NORTHERN STATES POWER COMPANY

MONTICELLO NUCLEAR GENERATING PLANT
Docket No. 50-263 License No. DPR-22

Response to 2/4/76 Questions on MSL Setpoints and MCPR

SCRAM REACTIVITY FOR MONTICELLO CYCLE 5

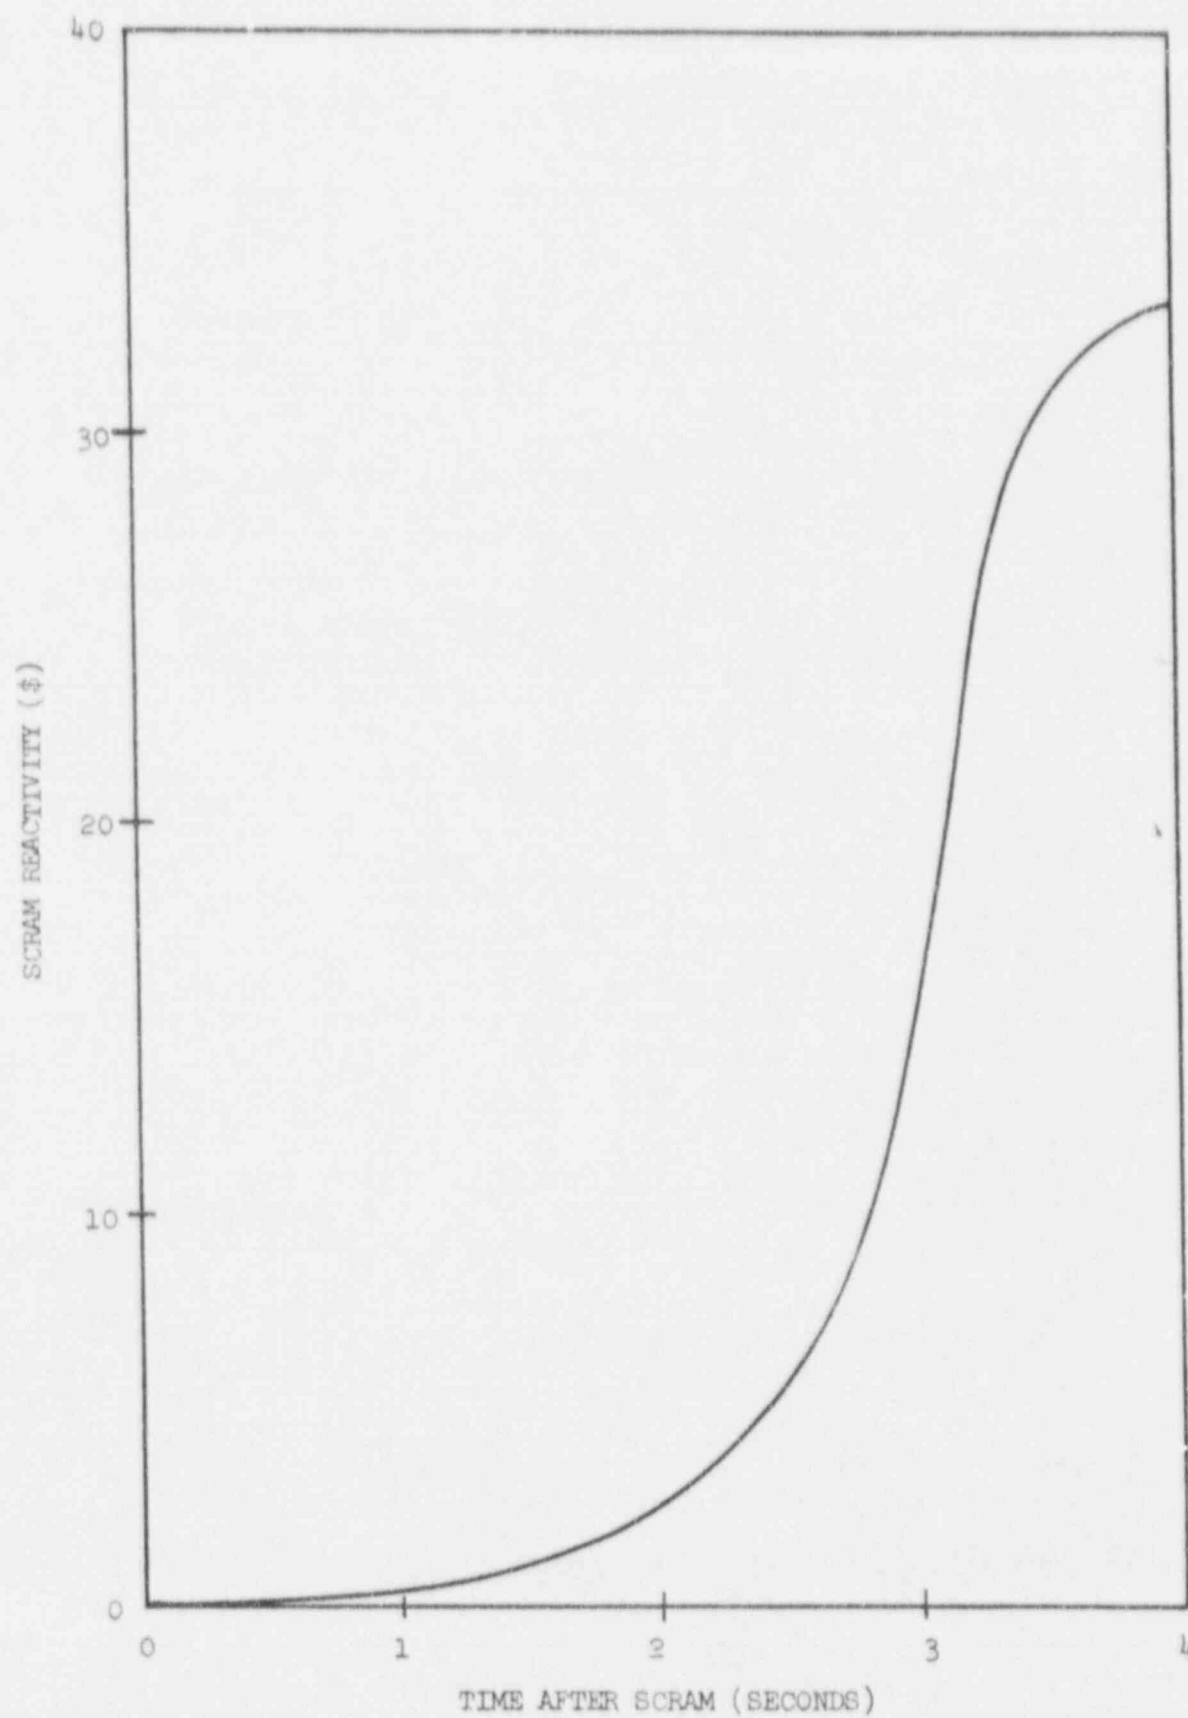
Provide the scram reactivity curve for EOC5.

The attached figure shows the scram reactivity used in the Cycle 5 analyses. This is conservatively derated to 80% of the expected value.
